# STAFF REPORT

- FROM: Deborah Hewett, Consent Planner, Subdivision
- **REFERENCE:** RM060545
- SUBJECT: M HUME and K JARRETT REPORT EP07/02/14 Report prepared for 19 February 2007 hearing

SUBJECT: 357 OBJECTION – HUME AND JARRETT, 19-21 WAITAPU ROAD

The subdivision plan (Attachment 1) shows the location of the property and the Rightof-way A.

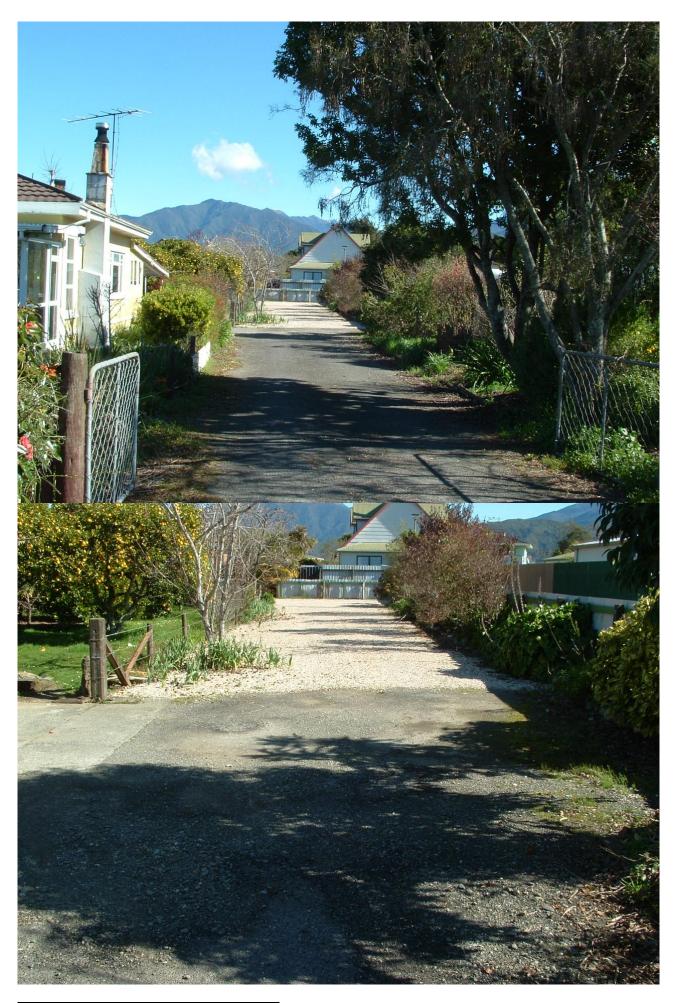
- 3. The access at present is substandard for a right-of-way; whilst there is sufficient width to meet the minimum legal width the formation and seal standards are not adequate. No kerb and channel is provided for stormwater management (and sumps) and an area of the proposed right-of-way is not sealed. In some places the existing seal has failed.
- 4. It is possible to further subdivide Lot 2 or erect a second dwelling as a controlled activity with the present arrangement of dwellings any access would make use of the right-of-way.

The application and attached photos show that parts of the access have a seal coat which is showing signs of deterioration and parts of the access are in a gravel formation.

The present surfacing which has an unknown pavement depth may fail prematurely due to lack of pavement depth and lack of stormwater control where stormwater can gain access to those pavement layers. Subsequently, soft areas will eventuate and failure will occur.

The southern part of the proposed right-of-way is also only formed with gravel and again, with increased vehicle use, will deteriorate over time.

That the section 357 objection be declined and Condition 3 be upheld.

It is Engineering's view that the right-of-way needs to be constructed to a standard. If the existing pavement under the seal can be shown to be competent in regard to base-course depth and compaction, then that area may only need to be patched and resealed.

The remaining unformed parts of the right-of-way to gain the 3.5 metre width, together with stormwater control, i.e. kerb and channel and sumps are required to be formed up and constructed.
